REVISION: OVERSIGHT CONCERN - DATED FEBRUARY 23RD, 2022
SHEETS: A102, A103, A105, A200, A201, A203, A204, A300, A4.03

NO.	DESCRIPTION	DATE
1	REVISED AS PER CITY COMMENTS - DP	2021-10-27
2	OVERSIGHT COMMENTS	2022-02-23

364 E 14TH STREET
DUPLEX INFILL
COVER SHEET

INFILL & EXISTING H.H. - E & W ELEVATIONS

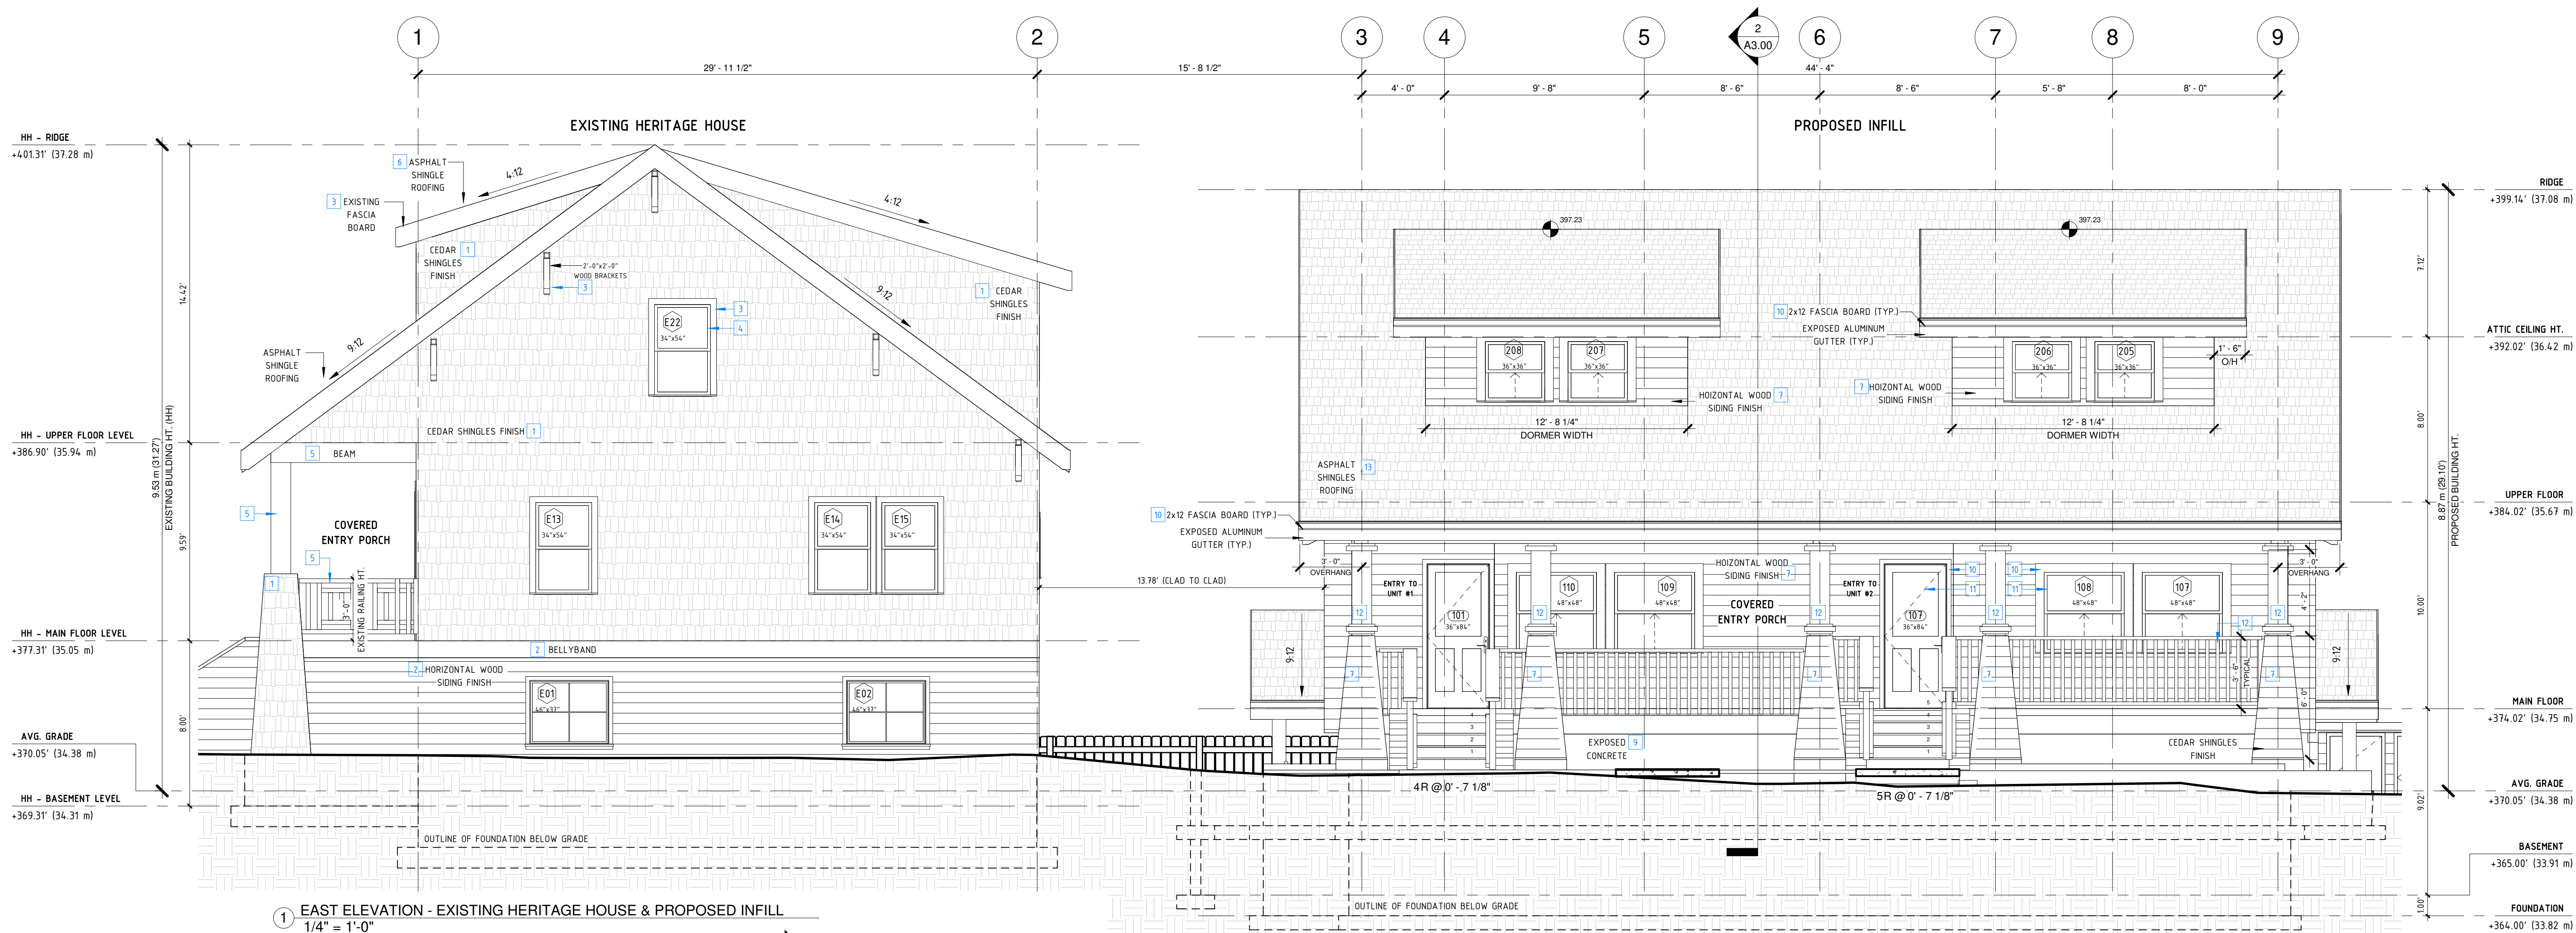
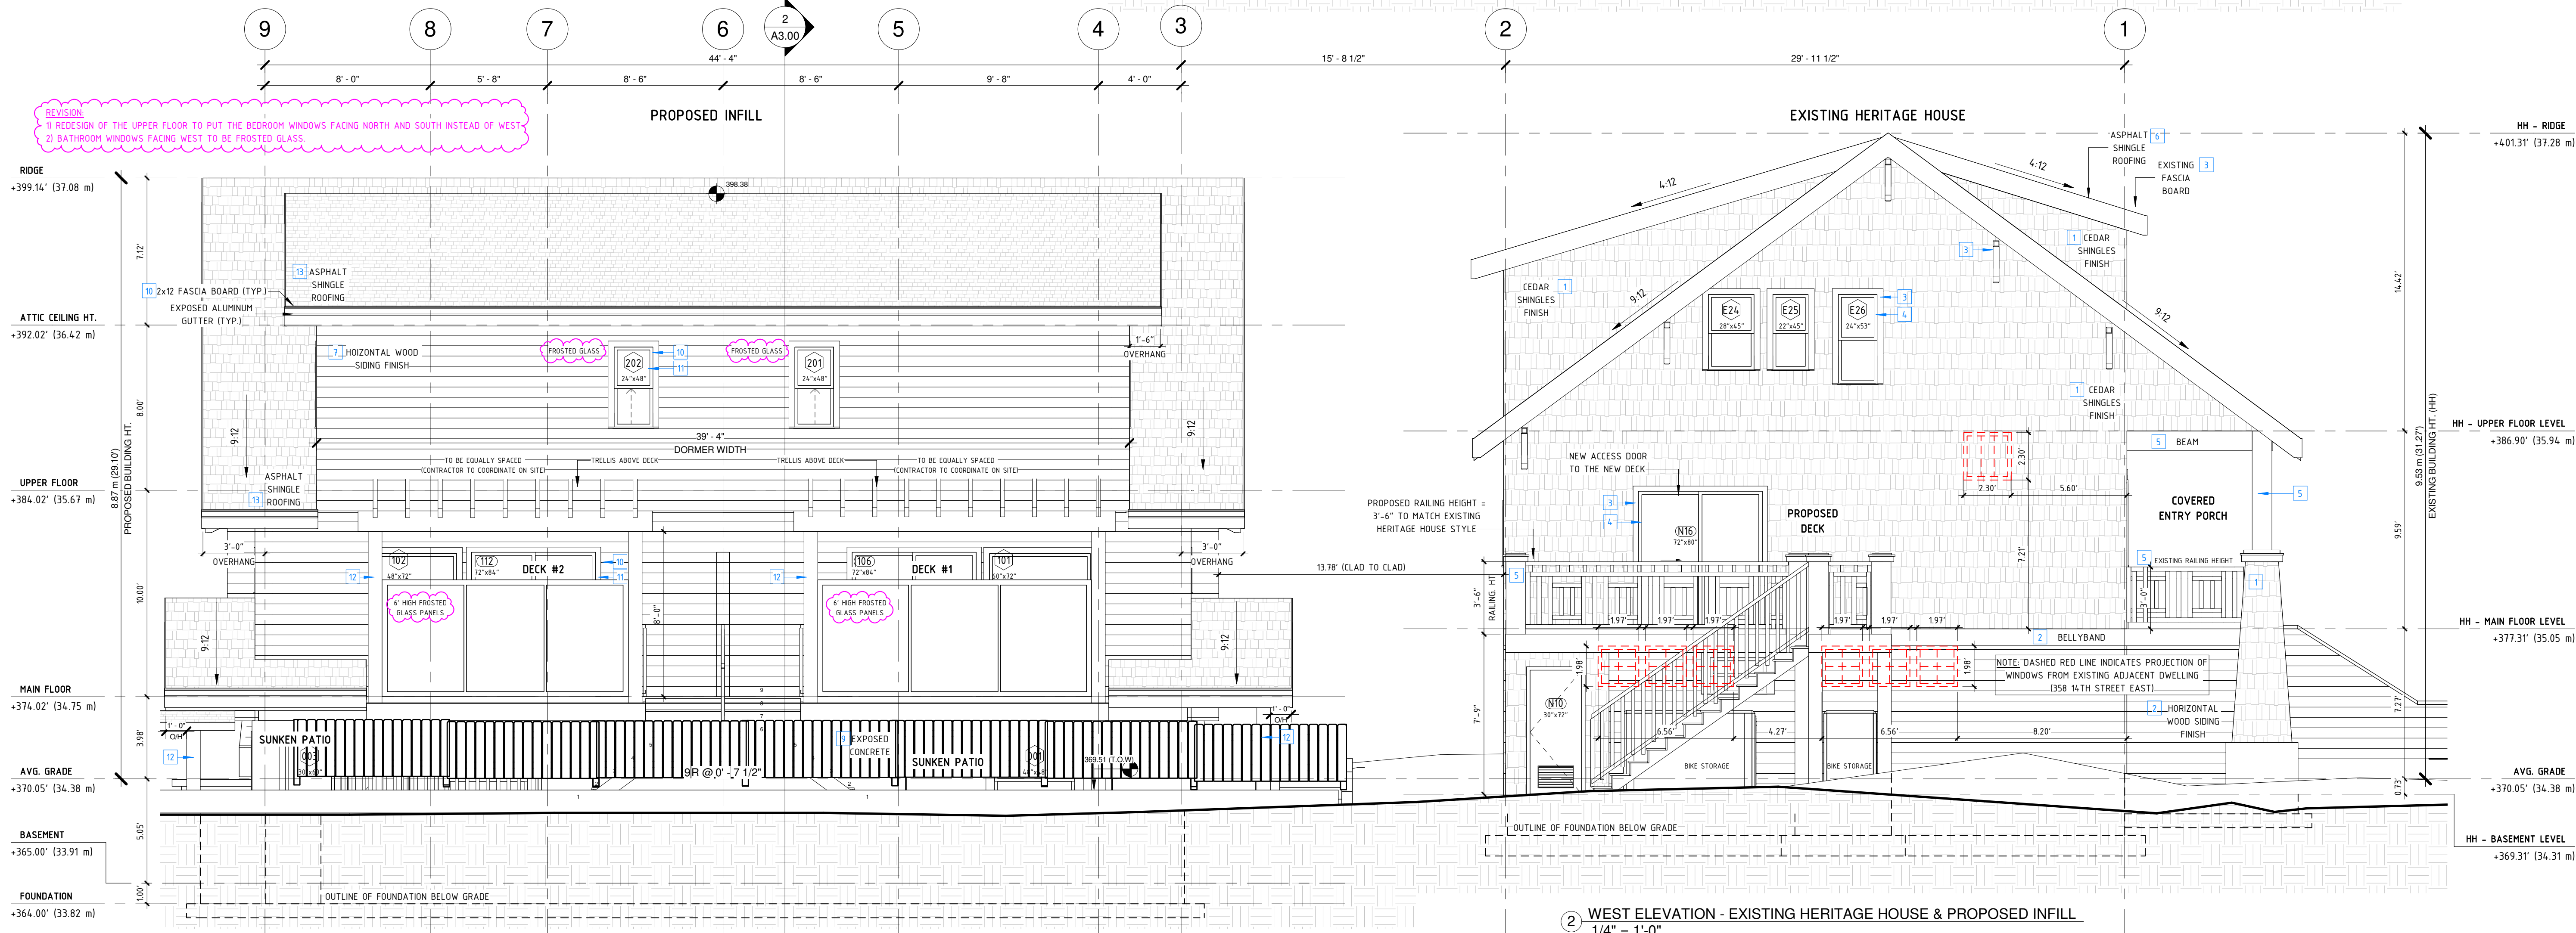
REVISION
1 REDESIGN OF THE UPPER FLOOR TO PUT THE BEDROOM WINDOWS FACING NORTH AND SOUTH INSTEAD OF WEST
2 BATHROOM WINDOWS FACING WEST TO BE FROSTED GLASS
